**Metro Manila Subway Project Phase 1  
PACKAGE CP104: (ORTIGAS NORTH AND ORTIGAS SOUTH)**

ITEM NO.	REFERENCE/CLAUSE/SECTION	QUERIES	RESPONSE
<i>Volume I Part 1 : Bidding Procedures</i>			
1.	Section II Bid Data Sheet (BDS) BDS-4 ITB 14.7	Bidder would like to confirm if payment of documentary stamps for Insurance policy shall also be exempted or not.	The costs of stamp duties and similar charges (if any) imposed by law in connection with entry into the Contract Agreement shall be borne by the Employer.

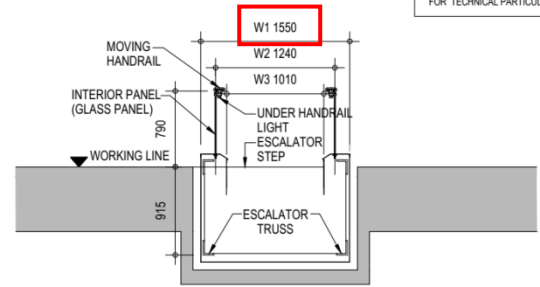
DRG No. STN-MEP-VAC-ON-3826	SHEET No.												
DRG S.	REV 4												
10.	Bill of Quantities Bill 5A, Item 1233 (1)STN-AR-A-ON-1002 to STN-AR-A-ON-1004, STN-MEP-VAC-ON-3828, STN-MEP-VAC-ON-3829	<p>Please clarify which of the following conflict items shall prevail:</p> <table border="1" style="width: 100%; border-collapse: collapse; text-align: center;"> <thead> <tr> <th style="background-color: #cccccc;">Description</th> <th style="background-color: #ffff00;">As per MEP Plan</th> <th style="background-color: #ccccff;">As per Architectural Plan</th> <th style="background-color: #ffcc99;">As per BOQ</th> </tr> </thead> <tbody> <tr> <td>North Station ESCA 5 - 8 Step width</td> <td>1010 mm</td> <td>1000 mm</td> <td>1550 mm</td> </tr> </tbody> </table>	Description	As per MEP Plan	As per Architectural Plan	As per BOQ	North Station ESCA 5 - 8 Step width	1010 mm	1000 mm	1550 mm	<p>Escalator step width shall be minimum 1000 mm. However, BOQ description provides total width of escalator requirements including housing. Please Refer to MEP Plan Drawing below</p>

<table><tr> <td style="width: 60%; text-align: center;">METRO MANILA SUBWAY PROJECT PHASE1</td> <td style="width: 40%;">DATE August 2020</td> </tr><tr> <td></td> <td>DRG No. STN-MEP-VAC-OS-3822</td> </tr></table>

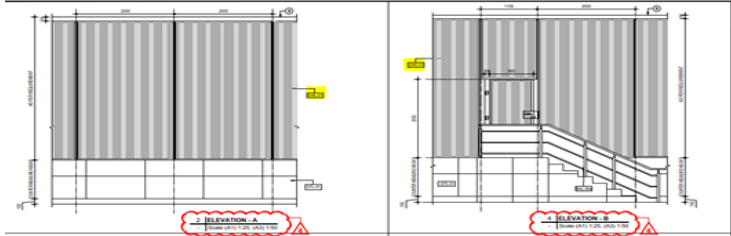
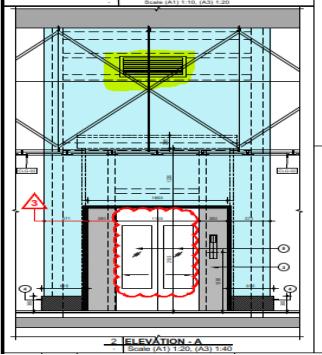
14.	Bill of Quantities Bill 5B, Item 1233 (1)MEP-VAC-OS- 3822, MEP-VAC-OS-3823, MEP-AR-A-OS-1001	<p>Please clarify which of the following conflict items shall prevail:</p>	<p>Escalator step width shall be minimum 1000 mm. However, BOQ description provides total width of escalator requirements including housing.</p> <p>Please refer to MEP Plan Drawing Below.</p>

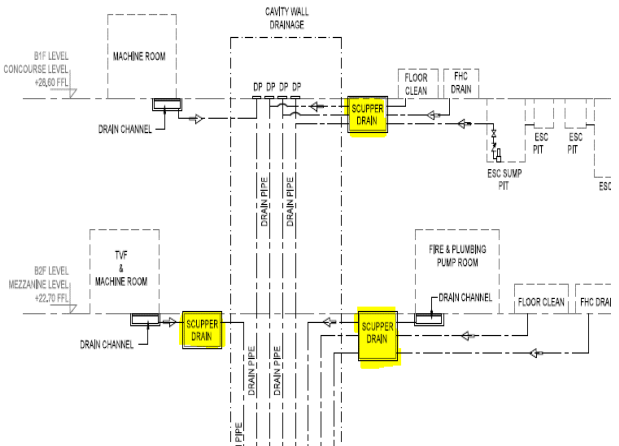
56.	STN-MEP-PLD-OS-3233	Kindly verify/provide drainage piping layout and size of floor drain located at Ortigas South Station near Staircase 6 (Grid B-19) at Platform Level.	Pipe routing for platform level FD comes in Under-platform level, Under-platform level is under Civil scope which is stated in Drainage Layout & Schematic
57.	STN-MEP-PLD-OS-3234	Kindly verify/provide drainage piping layout and size of floor drain located at Ortigas South Station near Access Hatch (Grid B-32) at Platform Level.	Pipe routing for platform level FD comes in Under-platform level, Under-platform level is under Civil scope which is stated in Drainage Layout & Schematic

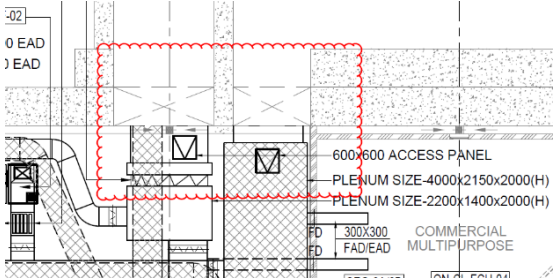
58.	STN-MEP-PLD-OS-3221	<p>Kindly provide/verify the drainage piping layout from the 300mm wide drain channel located at Ortigas South Station Mezzanine Level (Grid A-7)</p> 	There will be no piping to drain, water from 300mm wide drain channel. From 300mm drain channel it will goes to nearby FD directly
59.	STN-MEP-PLD-ON-2201 STN-MEP-PLD-OS-2201	Kindly verify what type of scupper is shown. Also, provide detailed drawing.	Details of Scupper drain is in Arch. Scope, Refer STN-AR-A-ON-9180 for details

METRO MANILA SUBWAY PROJECT PHASE1	DATE August 2020												
PACKAGE CP 104	SCALE AS SHOWN												
Ortigas South Station Escalator No. 3 (Sheet 1)	SHEET No.												
	DRG No. STN-MEP-VAC-OS-3827												
	DRG S. <span style="float: right;">REV 4</span>

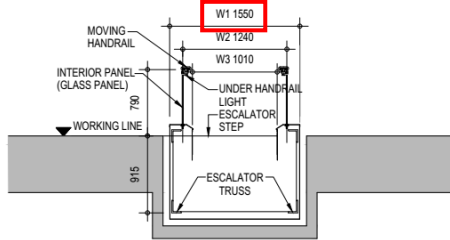
63.	STN-MEP-VAC-OS-3827	<p>In reference to Escalator Rise, the plan lay-out shows 12.15meters of rise. However, in the same plan, the escalator summary shows an escalator rise of 11.25meters. Which will prevail?</p>	<p>Escalator rise shall be 12150 mm</p> <p>Bidder to refer to the information below, And bidder to understand the drawing before making such query.</p>

METRO MANILA SUBWAY PROJECT PHASE1	DATE August 2020												
PACKAGE CP 104	SCALE AS SHOWN												
Ortigas South Station Escalator No. 3 (Sheet 3)													
DRG No. STN-MEP-VAC-OS-3829	SHEET No.												
DRG S.	REV 4

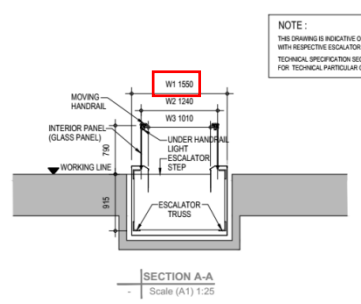
64.	Bill of Quantities Bill 5B, Item 1233 (1)  MEP-VAC-OS-3825, MEP-VAC-OS-3826, MEP-AR-A-OS-1001	Please clarify which of the following conflict items shall prevail: <table border="1" style="width: 100%; border-collapse: collapse; margin-top: 10px;"> <thead> <tr> <th style="width: 25%;">Description</th> <th style="width: 25%;">As per MEP Plan</th> <th style="width: 25%;">As per Architectural Plan</th> <th style="width: 25%;">As per BOQ</th> </tr> </thead> <tbody> <tr> <td>South Station ESCA 2 Step width</td> <td style="text-align: center;">1010 mm</td> <td style="text-align: center;">1000 mm</td> <td style="text-align: center;">1550 mm</td> </tr> </tbody> </table>	Description	As per MEP Plan	As per Architectural Plan	As per BOQ	South Station ESCA 2 Step width	1010 mm	1000 mm	1550 mm	Escalator step width shall be minimum 1000 mm. However, BOQ description provides total width of escalator requirements including housing.

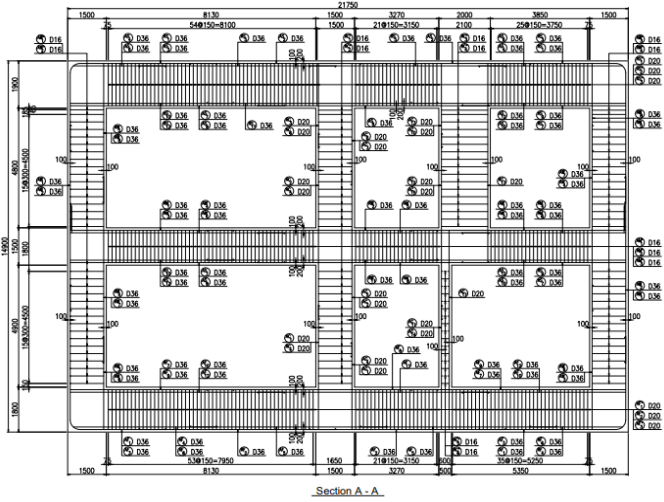
66.	Bill of Quantities Bill 5B, Item 1233 (1)  MEP-VAC-OS-3831, MEP-VAC-OS-3832, STN-AR-A-OS-1002, STN-AR-A-OS-1003	Please clarify which of the following conflict items shall prevail: <table border="1" style="width: 100%; border-collapse: collapse; margin-top: 10px;"> <thead> <tr> <th style="width: 25%;">Description</th> <th style="width: 25%;">As per MEP Plan</th> <th style="width: 25%;">As per Architectural Plan</th> <th style="width: 25%;">As per BOQ</th> </tr> </thead> <tbody> <tr> <td>South Station ESCA 4-5 Step width</td> <td style="text-align: center;">1010 mm</td> <td style="text-align: center;">1000 mm</td> <td style="text-align: center;">1550 mm</td> </tr> </tbody> </table>	Description	As per MEP Plan	As per Architectural Plan	As per BOQ	South Station ESCA 4-5 Step width	1010 mm	1000 mm	1550 mm	Escalator step width shall be minimum 1000 mm. However, BOQ description provides total width of escalator requirements including housing.

Description	As per MEP Plan	As per Architectural Plan	As per BOQ										
South Station ESCA 4-5 Step width	1010 mm	1000 mm	1550 mm										
67.	Bill of Quantities Bill 5B, Item 1233 (1)STN-MEP-VAC-OS-3834, STN-MEP-VAC-OS-3835, STN-AR-A-OS-1004 to STN-AR-A-OS-1005	Please clarify which of the following conflict items shall prevail:	Escalator step width shall be minimum 1000 mm. However, BOQ description provides total width of escalator requirements including housing. Please refer to the MEP Plan Drawing below

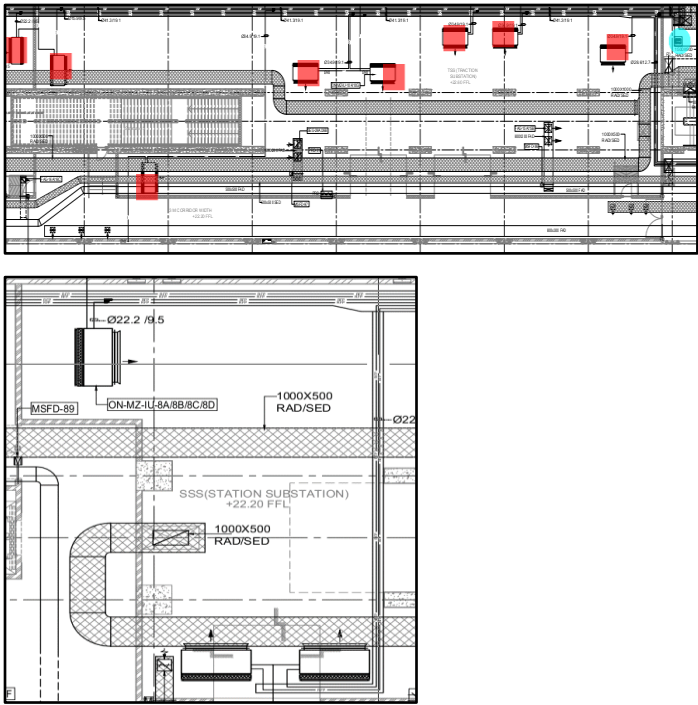
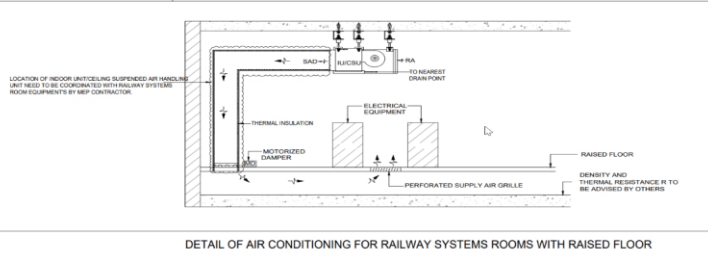
75.	Bill 5A/5B Pay item No. 1237 (5) STN-MEP-PLD-ON-5101/ STN-MEP-PLD-OS-5101	<p>In reference to Bid Bulletin No.5, Revised BOQ, the quantity for Water Heater (SL No.2 to 4) does not match the equipment schedule. Please clarify which quantity will prevail.</p> <p>As per BOQ:</p> <table border="1" style="width: 100%; border-collapse: collapse; text-align: center;"> <thead> <tr style="background-color: #cccccc;"> <th style="width: 70%;">DESCRIPTION</th> <th style="width: 10%;">UNIT</th> <th style="width: 20%;">QTY</th> </tr> </thead> <tbody> <tr> <td>Electric water heater; 15L capacity; horizontal wall mounted, 1.5kW; 3ph; 380V; 60Hz, ref SL no.2 to 4</td> <td>pc</td> <td>5.00</td> </tr> </tbody> </table>	DESCRIPTION	UNIT	QTY	Electric water heater; 15L capacity; horizontal wall mounted, 1.5kW; 3ph; 380V; 60Hz, ref SL no.2 to 4	pc	5.00	<p>BOQ updated following latest equipment schedule. Please see screenshot below.</p> <p>OSS - BOQ</p> <table border="1" style="width: 100%; border-collapse: collapse; text-align: center;"> <thead> <tr> <th style="width: 60%;">Description</th> <th style="width: 10%;">Quantity</th> <th style="width: 10%;">Unit</th> <th style="width: 20%;">Remarks</th> </tr> </thead> <tbody> <tr> <td>Water heater; complete with driving motor, all necessary accessories and connection, electrical/control wirings, conduits and complete as in the equipment schedule and as described</td> <td></td> <td></td> <td></td> </tr> <tr> <td>1237(5) Electric water heater; 25L capacity; horizontal wall mounted, 2kW; 3ph; 380V; 60Hz, ref SL no.1</td> <td>2</td> <td>pc</td> <td></td> </tr> <tr> <td>1237(5) Electric water heater; 15L capacity; horizontal wall mounted, 1.5kW; 3ph; 380V; 60Hz, ref SL no.2 to 4</td> <td>5</td> <td>pc</td> <td></td> </tr> </tbody> </table> <p>OSS - Equipment Schedule</p>	Description	Quantity	Unit	Remarks	Water heater; complete with driving motor, all necessary accessories and connection, electrical/control wirings, conduits and complete as in the equipment schedule and as described				1237(5) Electric water heater; 25L capacity; horizontal wall mounted, 2kW; 3ph; 380V; 60Hz, ref SL no.1	2	pc		1237(5) Electric water heater; 15L capacity; horizontal wall mounted, 1.5kW; 3ph; 380V; 60Hz, ref SL no.2 to 4	5	pc
